## DELEGATE REPORT MINISTERIAL PLANNING REFERRAL

<b>Application no:</b>	TPMR-2023-7
<b>DTP reference no:</b>	DP2302292
<b>Applicant:</b>	Lendlease Development Pty Ltd C/- Urbis Pty Ltd
<b>Owner:</b>	Melbourne City Council
<b>Architects:</b>	3XN Australia, Kerstin Thompson Architects and NH Architecture
<b>Address:</b>	Queen Victoria Market Precinct Southern Site 65-159 Victoria Street, Melbourne
<b>Proposal:</b>	Queen Victoria Market Southern Precinct Development Plan
<b>Cost of works:</b>	Not applicable
<b>Date received:</b>	8 June 2023
<b>Date amended:</b>	13 December 2023
<b>Responsible officer:</b>	Lachlan Orr, Principal Urban Planner

The application seeks the endorsement of the 'Queen Victoria Market Southern Precinct Development Plan, December 2023' which applies to Parcel C and Parcel D, the proposed public open space and surrounding roads as set out in the Queen Victoria Market Framework Plan under DPO11.

Figure 16: Site plan illustrating tower setbacks and separation

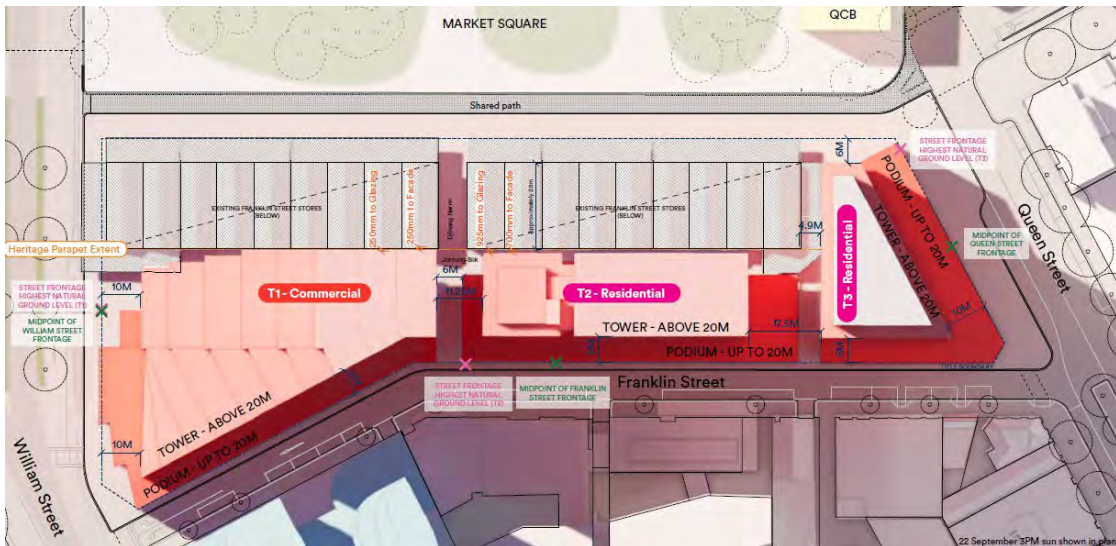
The tower setbacks reinforce the consistent street wall and podium height sought for Parcel D, and together with the tower separation, ensure acceptable outlook and solar access to building occupants, the public realm as well as adjacent land to the south and east. The staggered setbacks to Tower 1 result in a rotating mass around the western gateway to the precinct which appropriately addresses Flagstaff Gardens and transitions to the taller buildings in the precinct and beyond in the CBD.

**Figure 17: Massing diagram facing south illustrating tower massing and separation**

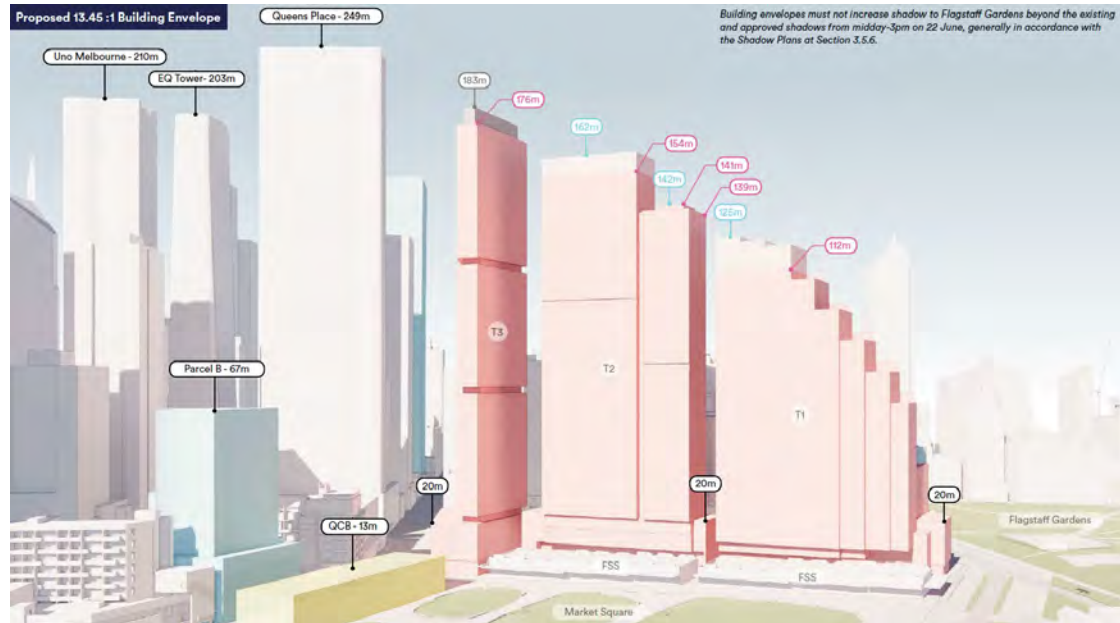
street level. The proposed tower separation would also ensure daylight, privacy and outlook for building occupants.

Figure 19: Section of the proposed cantilever and east-west link at Tower 1

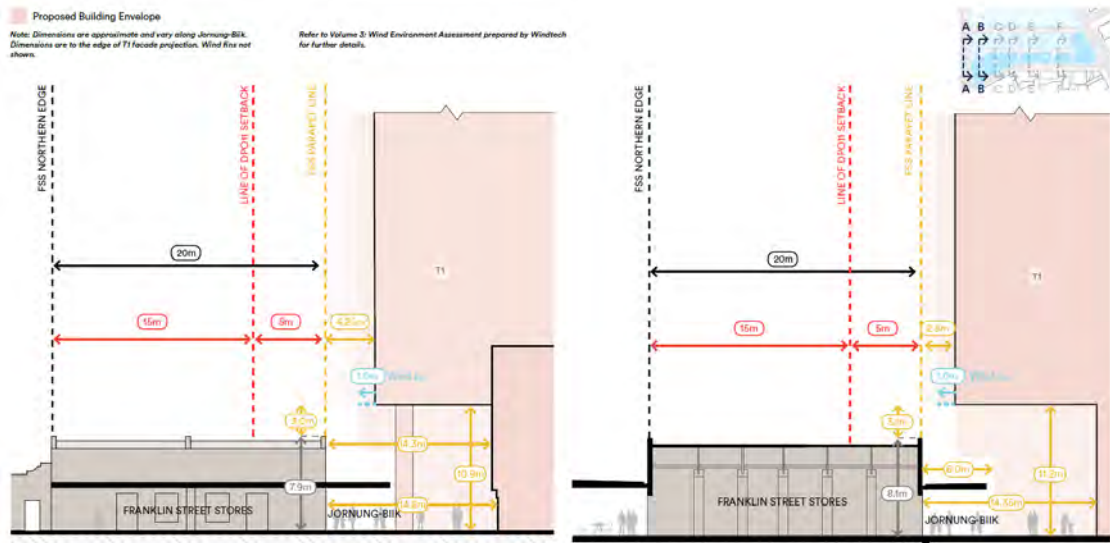
- The new public realm around the towers and Franklin Street Stores, including managing the impact of the cantilever above the new east-west laneway and the edge of the towers to the Franklin Street Stores.
- The public realm response for each tower at ground level, ensuring they achieve a positive condition at a pedestrian level and provide an effective laneway network that will be legible as part of the Hoddle Grid.
- The design of the shared zone to enhance relationship between the new public open space and the development.

**Figure 20: Shadow diagrams for Flagstaff Gardens on 22 June between 11:00am and 12:00pm (shadows from the proposed development in navy blue)**

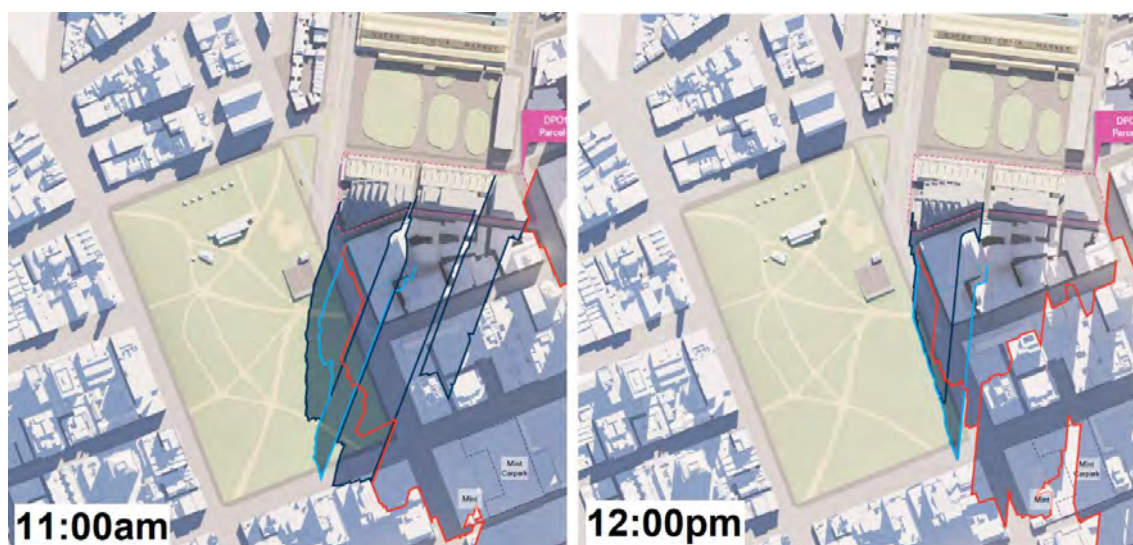
- From 12:00pm onward, the development would not overshadow Flagstaff Gardens. This outcome would be compliant with the proposed controls in Amendment C415, which require there to be no additional shadow cast from 12:00pm to 3:00pm.

Figure 21: Shadow diagrams on 21 June for Market Square at 11:00am and 12:00pm

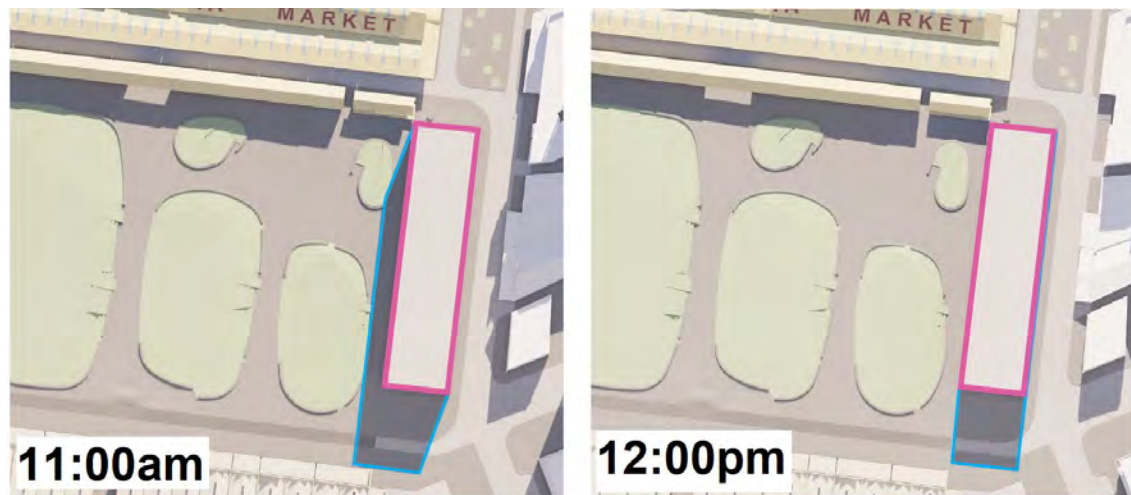
The shadow analysis shows that there will be minimal overshadowing to the proposed public open space (Market Square) at 11:00 am on 21 June as a result of the allowable building envelope for Parcel C. By 12:00 pm, there would be no additional shadow to Market Square. The minor extent of overshadowing to Market Square is consistent with the level of allowable shadowing under the DPO11 Parcel C building envelope. The shadowing is also offset by the additional area provided to Market Square through the reduction of the shared zone / path. Future planning permit applications would not challenge this outcome given the mandatory maximum building height for Parcel C, as well as the buildings in Parcel D being located to the south of Market Square.

Figure 25: Market Square site plan with extension beyond PPRZ area highlighted

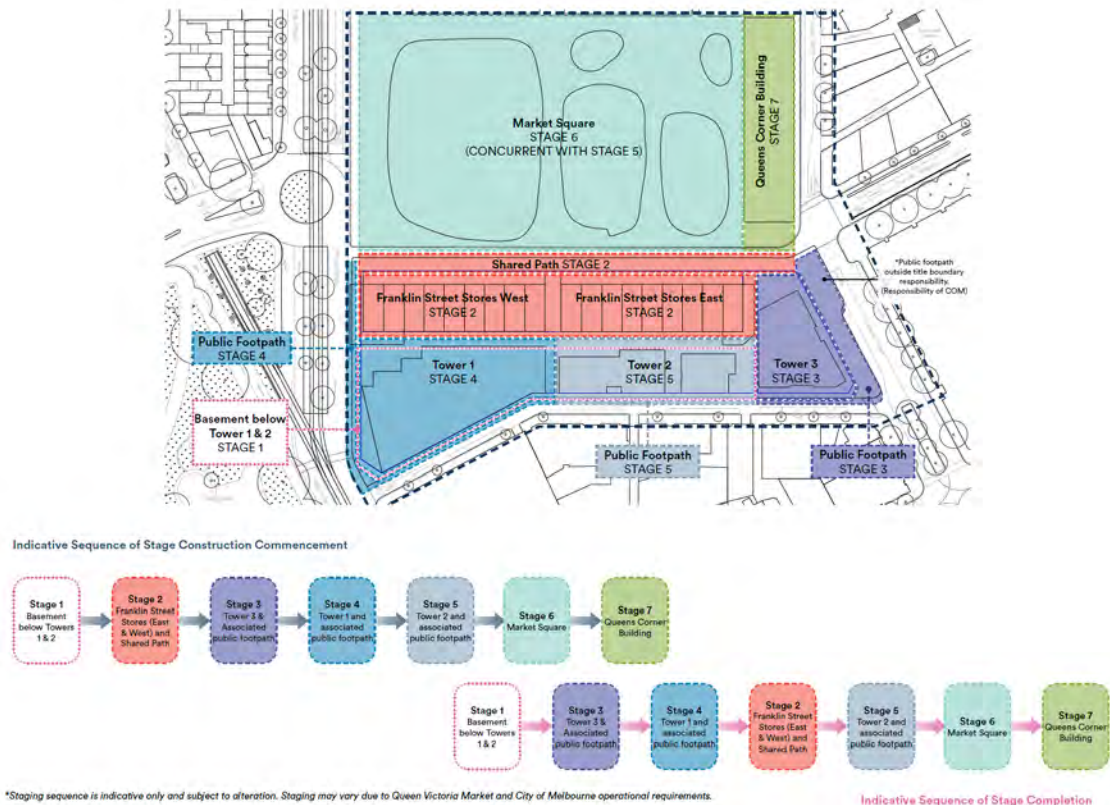
The development plan provides for an extension to the area provided for the future public open space by reducing the area dedicated to shared zone in the Framework Plan. There is discretion to accommodate this modification under the DPO11 as there are no buildings proposed in either space, and there are no other requirements that the change would conflict with. Rather, the change would achieve a greater level of alignment with DPO11 by promoting a higher level of amenity and a more pedestrian friendly environment within the precinct.
